Economic Commission for Europe**Inland Transport Committee****World Forum for Harmonization of Vehicle Regulations****Working Party on Lighting and Light-Signalling****Sixty-ninth session**

Regulation No. 48 - Proposal for amendments to the 06 series of amendments**Proposal for Supplement 3 to the 06 series of amendments to Regulation No. 48 (Installation of lighting and light-signalling devices)****Submitted by the expert from Poland ***

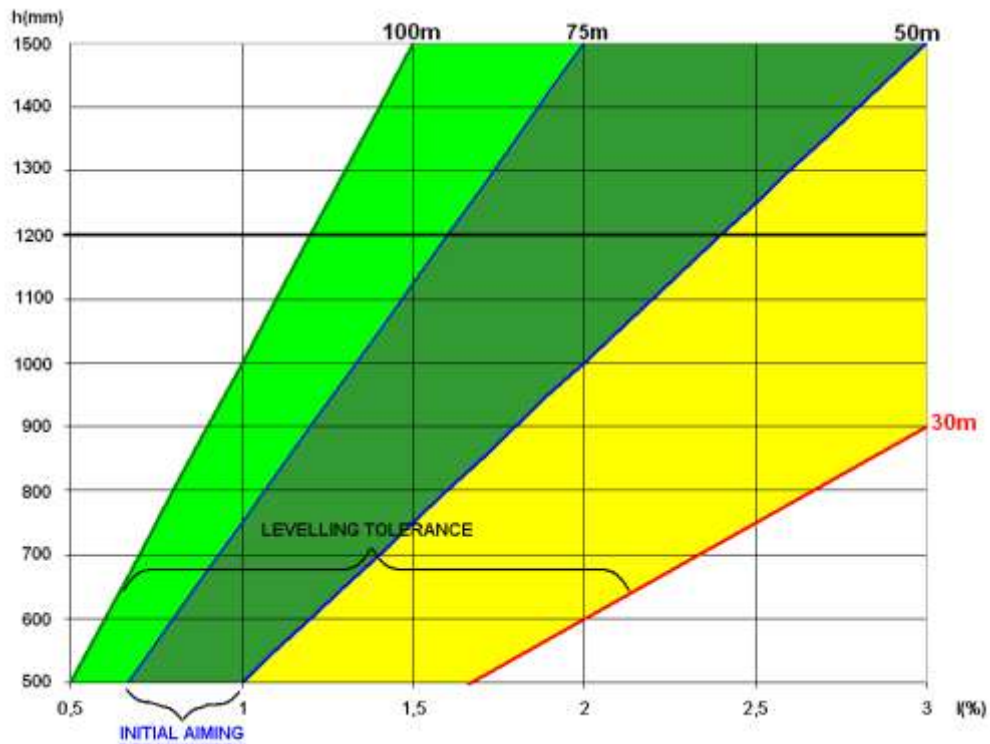
"6.2.6.1.3. Depending on the mounting height in millimetres (h) of the dipped-beam headlamp reference axis, the vertical inclination of the cut-off of the dipped-beam (in the direction of the reference axis) measured on the unladen vehicles, taking in account 0.1 per cent accuracy, shall have the value of initial downward inclination (initial aiming) for which the horizontal part of the cut-off intersects with the surface of a flat horizontal road at a distance between [50] m and [75] m from the headlamp.

The aiming limits under all the static conditions of Annex 5 shall be such that the distance of intersection of the vertical part of the cut-off with the road surface shall remain between [30] m and [100] m, including aiming inaccuracy (see figure below).

At the discretion of the manufacturer the minimum distance of intersection of the horizontal part of the cut-off with the road surface longer than [30]m can be declared.
